SERVICE BULLETIN

APPLICABILITY: 2024-26MY Impreza & Crosstrek
 2025-26MY Forester
 2024-26MY WRX

NUMBER: 15-341-26

SUBJECT: CID to CCU Cord / Design Change

EXAMPLE VIDEOS:

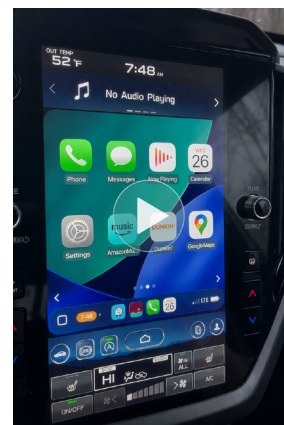
This bulletin announces a design change to the cord assembly that connects the Center Infotainment Display (CID) to the CCU, addressing reports of CID screen flickering. The redesigned cord is 35 mm longer to improve fitment. If the Center Infotainment screen is flickering, please follow the procedure outlined below.
